# LiDAR Quality Assessment Report

ARRA-MI\_LowerPeninsula\_2010

LiDAR Data Acquisition covering the Iosco, Arenac, and Bay Counties, MI

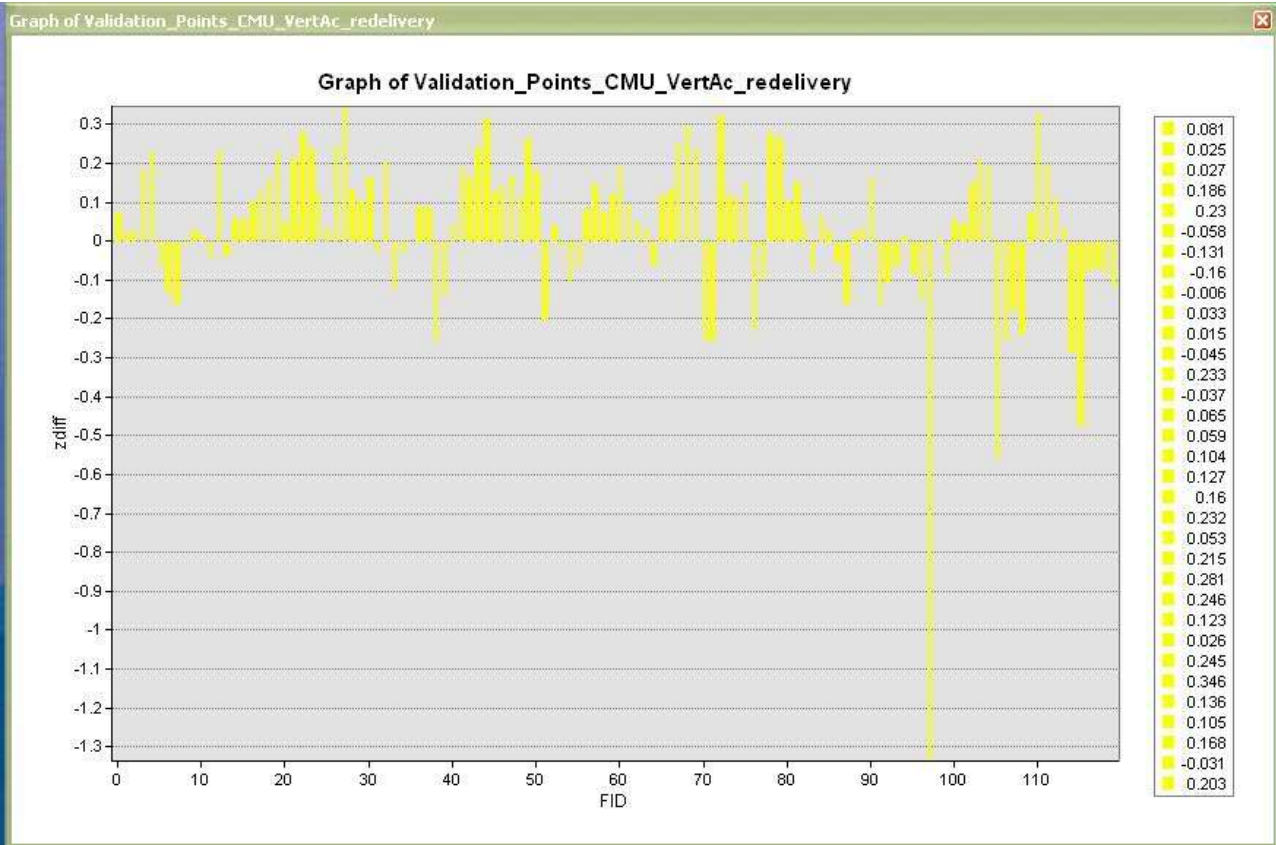
Redelivered Tiles Mosaiced into a Final Bare Earth DEM, all qualitative issues noted above have been fixed (note Lake Huron Extends out to cover the Island).
